**ADDRESS: 2458 BRUSH**

**APPLICATION NO: HDC2024-00660**

**HISTORIC DISTRICT: BRUSH PARK**

**SCOPE: INSTALL A LED SCREEN**

**2458 Brush, current appearance. Staff photo taken 11/25/2024**

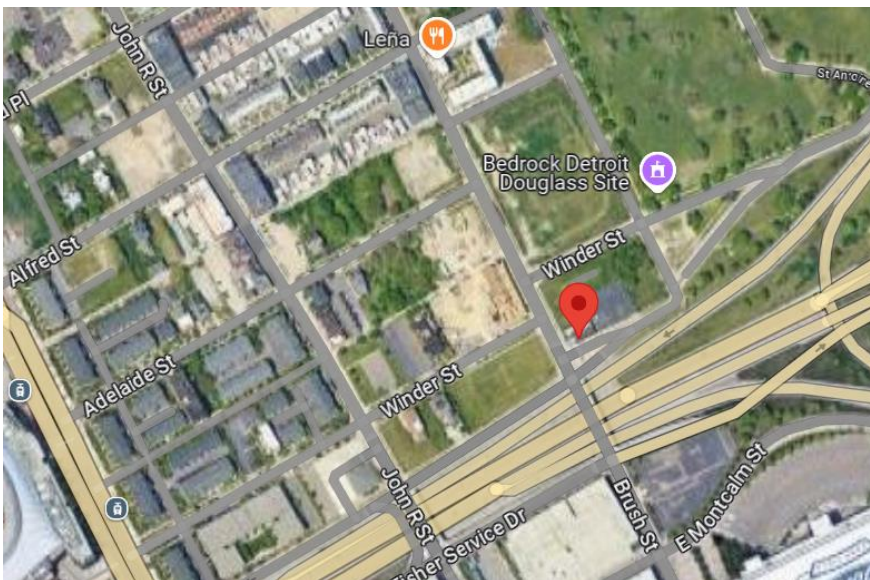
- Note that signage of this type (LED screens) does not currently exist within the district. Rather, signage is typically static in nature and when affixed to a building, is generally situated at a pedestrian level and is installed at a location which bears a direct relationship to the building's existing architectural features. The current application proposes to install the LED screen on a blank concrete side wall, facing the highway/in a position that is not pedestrian oriented and displays no architectural features which suggest that such signage is appropriate at that location. It therefore is staff's opinion that the project does not conform to the above-noted National Park Service guidelines and does not meet the Secretary of the Interior's Guidelines.

- The current application proposes to install the LED screen on a blank concrete side wall, facing the highway/in a position that is not pedestrian oriented and displays no architectural features which suggest that such signage is appropriate at that location.

### **Recommendation - Section 21-2-78. Determination of the Historic District Commission – Denial: Install a LED screen**

Therefore, staff recommends that the Commission deny the application because the work does not conform to the district's Elements of Design, nor does it meet Secretary of the Interior's Standards for Rehabilitation, specifically Standards #9, which states the following:
